# SERVICE INFORMATION

## STANDARD AND TRIUMPH VEHICLES

<b>No.</b>	SPORTS/2/F	REAR AXLE CROWN WHEEL ATTACHMENT	<b>Date</b>	JUNE 1954
------------	------------	----------------------------------	-------------	-----------

1 ILLUSTRATION.

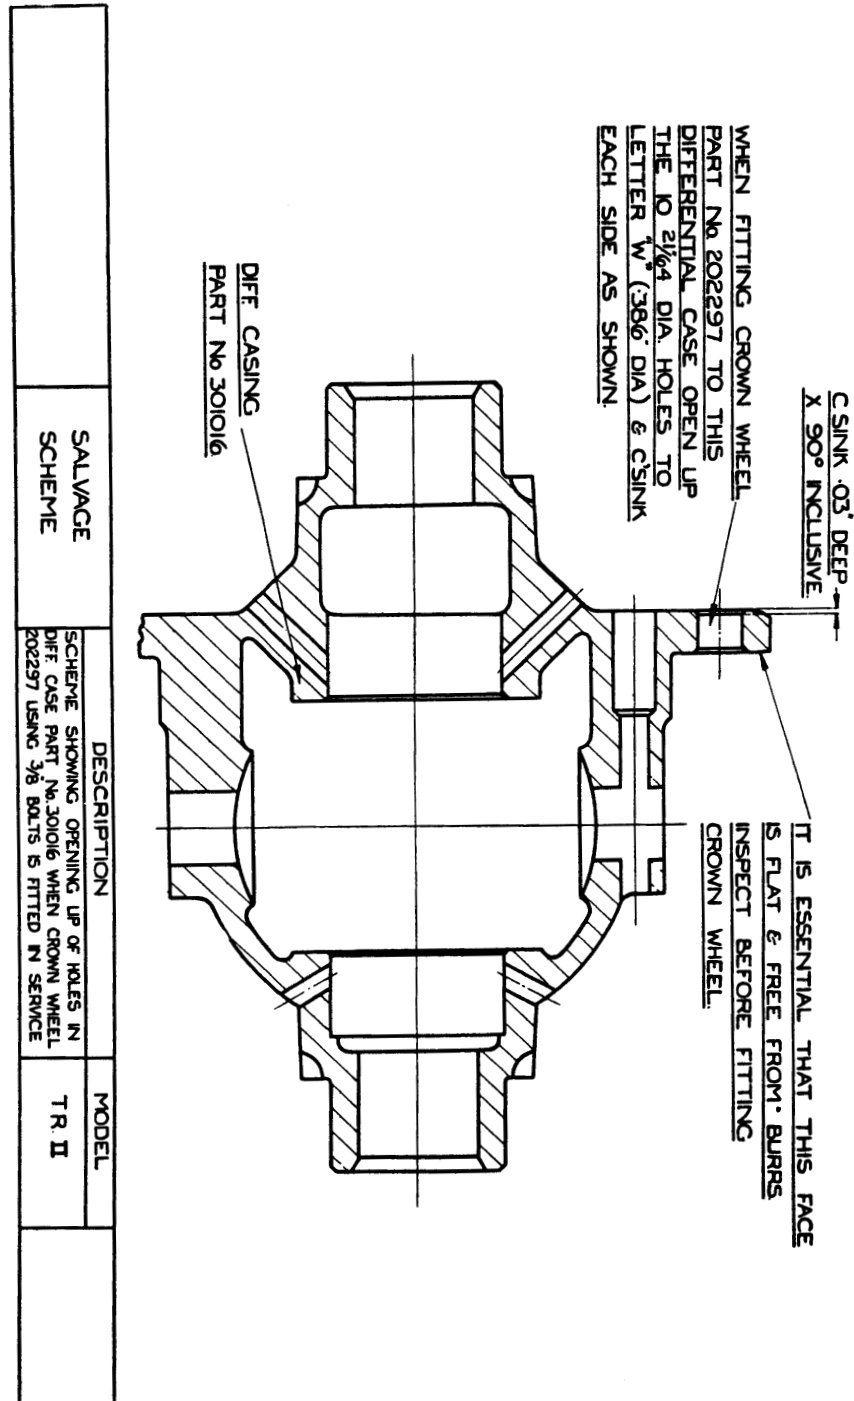
The crown wheel has shown a tendency to work loose on the differential housing after exacting rally forward and reversing tests, and it is recommended that the bolts should be checked for tightness to 22-24 lbs. ft. after the vehicle has competed in this type of event.

The attachment bolts are being increased from 5/16" to 3/8" diameter which, with the higher tightening torque of 35-40 lbs.ft. provides a far stronger clamping load. The Part Number of the new 3/8" Bolt is 109735 (8 off) and the Tab Washer, Part No. 109736 (2 off) and 109737 (2 off).

It is only intended to supply future crown wheel (with pinion) assemblies to suit the 3/8" diameter bolts, and these will be supplied under Part No. 502127. The original differential housing bolt holes should be opened out as shown in the illustration.

The original differential housing to suit the 5/16" bolts was supplied under Part No. 301016, and the later type to suit the 3/8" bolts will be sold under Part No. 301607.
